Subject: The Dow Chemical Company- License No. R-108; Docket No. 50-264

Enclosed are the responses to RAI letter, dated June 26, 2013, and the DTRR revised Technical Specifications. These documents are submitted as attachment I and attachment II respectively.

DTRR response to RAI letter dated June 26, 2013: Questions 1 through 22.

Revised DTRR Technical Specifications, July 2013

Figure 6.1. Administration

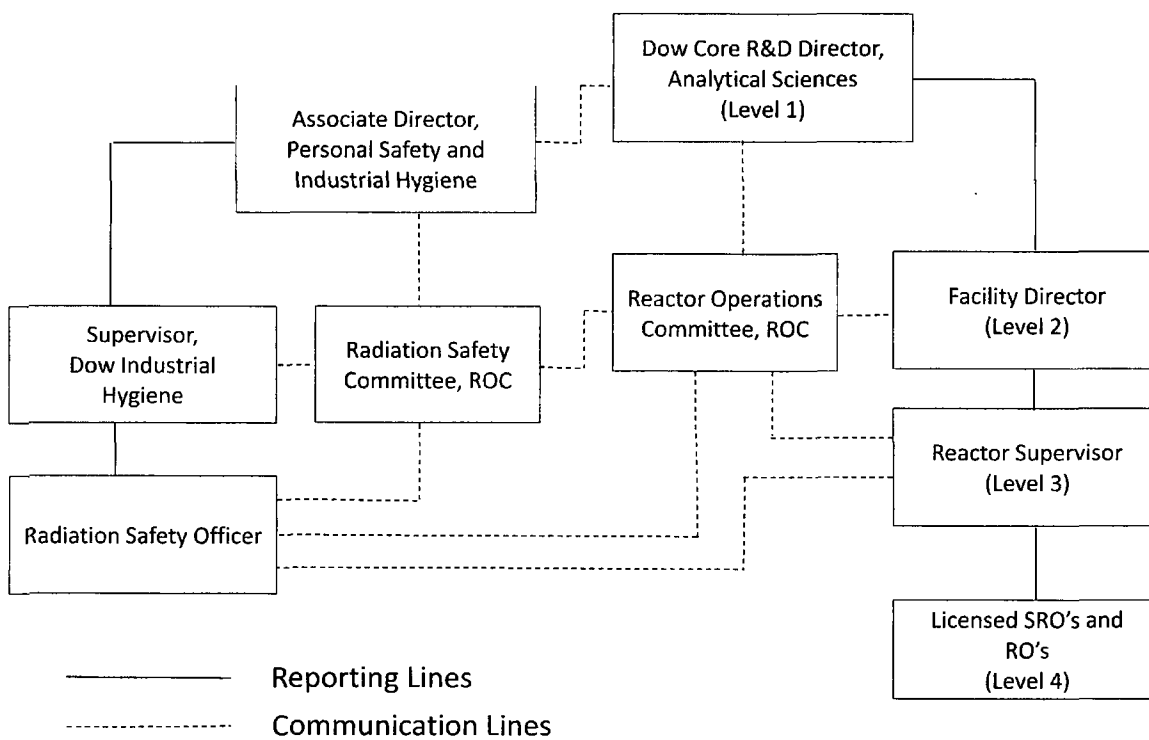
RAI-14. The proposed DTRR TS 6.1.2, Responsibility, does not indicate the reporting relationship (solid line in TS Figure 6.1) between the Radiation Safety Officer and the Dow Core R&D Director, Analytical Sciences (Level 1). Justify the proposed TS Figure 6.1 or propose a revised figure to indicate the reporting relationship.

The revised DTRR TS (July 2013) contains a revised figure 6.1 showing the reporting and communication relationships between the SRO and Director Analytical Sciences (Level1).
